STAFF REPORT

SUBJECT: H-2021-0051
Burger King Drive-Through – CUP

LOCATION: The site is located at 6211 N. Ten Mile Road, on the west side of N. Ten Mile Road, approximately 500 feet south of Chinden Boulevard (Lot 11, Block 1, Lost Rapids Subdivision), in the NE ¼ of the NE ¼ of Section 27, Township 4N., Range 1W.

A. Proposed Site Plan (dated: 9/03/2021)

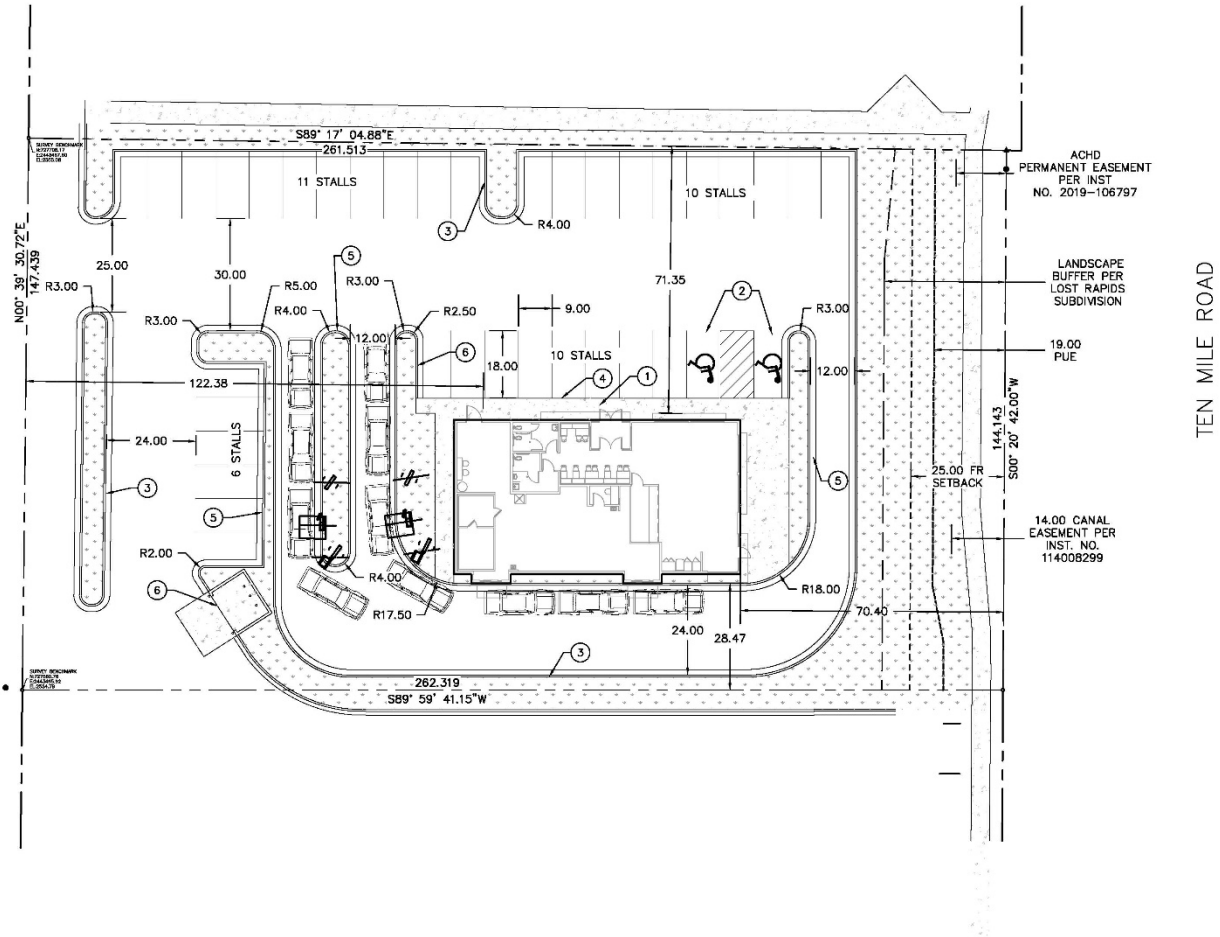
The proposed drive-through has two ordering menu boards with stacking for approximately three (3) vehicles per lane, according to the submitted site plan. Each stacking lane is approximately 60’ deep from the edge of the 30’ wide drive aisle that is proposed as the main access to the future building and the drive-through exit in the north end of the site. The proposed 30’ drive aisle is 5’ wider than required by code which allows some relief if stacking backs up into the drive aisle while ordering. The total stacking length is approximately 128’ from the edge of the drive aisle to the pick-up window along the south side of the building; this allows at least 7 vehicles to stack according to the submitted site plan.

Per the submitted site plan, the stacking lanes are off of the northernmost drive aisle and provide at least 120’ of stacking with each menu board location and approximately 128’ in total to the pick-up window before any vehicle would impede this drive aisle. No parking is impeded by the proposed stacking lanes and nor would any be should stacking exceed the proposed depth because of the site design.

The stacking lane exceeds 100' in length from the drive aisle to the pick-up window. Therefore, the Applicant has proposed an escape lane adjacent to the drive through lane along the southern boundary. This escape lane configuration meets this standard.

The drive-through is not directly adjacent to the nearest public street (N. Ten Mile Road) along the east boundary of the site but the south boundary of the site and the pick-up window is still visible from Ten Mile. To help meet this standard, Staff is recommending revisions to the landscape plan to remove some of the proposed landscaping that would obstruct the line of sight from the street to the pick-up window as currently proposed. If this cannot occur or would incur undue costs because the street landscaping is already in place, there is ample surveillance opportunity from within the commercial subdivision and internal drive aisles.

Pedestrian Walkways: No pedestrian walkway is depicted on the site plan from the arterial/perimeter sidewalk along N. Ten Mile Road to the main building entrance. UDC 11-3A-19B.4a requires this connection for all nonresidential uses. Therefore, Staff is recommending a

condition of approval to add a pedestrian connection near the drive-through exit that connects the arterial sidewalk to the patio area of the pad site.

1. Future development of this site shall comply with the existing Development Agreement (Inst. #[2018-079970](#), Lost Rapids - GFI Meridian Investments II, LLC) and associated conditions of approval (H-2018-0004; FP-2019-0056).
2. The site plan submitted with the future Certificate of Zoning Compliance application shall be revised as follows:
 - a. Depict a pedestrian walkway from the sidewalk along N. Ten Mile Road to the building entrance near the drive-through exit. Construct the pedestrian crossing of the drive-through, or any other pedestrian facility that crosses a vehicular use area, with a different material—stamped or colored concrete, brick pavers, or similar are acceptable forms of meeting this requirement per [UDC 11-3A-19B.4b](#).

B. Proposed Landscape Plan (dated: 7/08/2021)

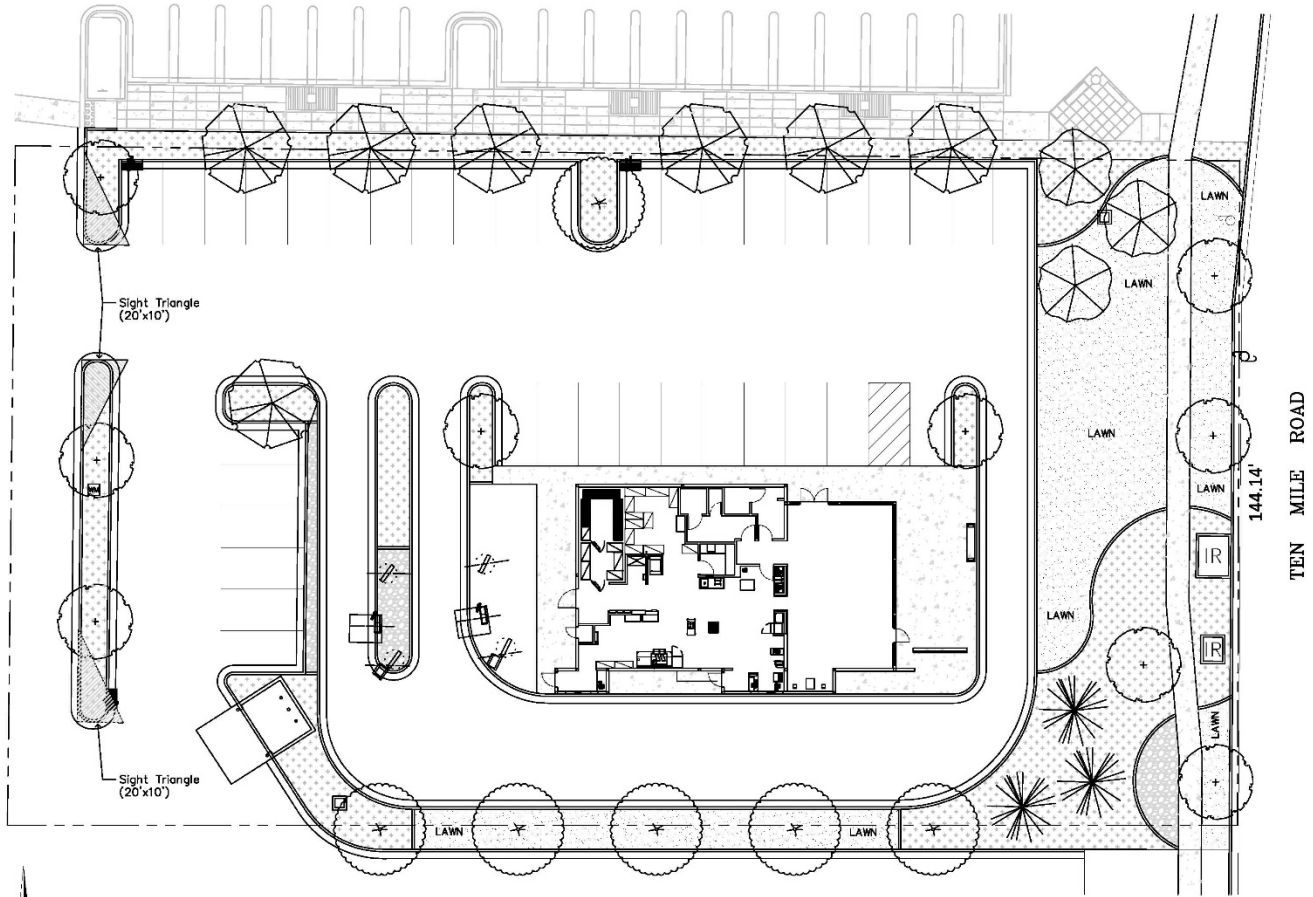
Street buffer landscaping, including a sidewalk, along N. Ten Mile Rd. was installed with development of the overall subdivision. The submitted landscape plans show a majority of this buffer remaining as it currently exists but Staff is recommending that the southern portion of the site have some of the trees removed to increase visibility from Ten Mile to the pick-up window. If the trees can be relocated to other areas of the site, Staff supports this.

3. The landscape plan submitted with the future Certificate of Zoning Compliance application shall be revised as follows:
 - a. Depict the required pedestrian walkway as noted above, per UDC 11-3A-19B.4a and UDC 11-3A-19B.4b.

- b. Revise the layout or reduce the number of trees shown in the southeast corner of the arterial street buffer to increase visibility from N. Ten Mile Road to the pick-up window and drive-through lane.
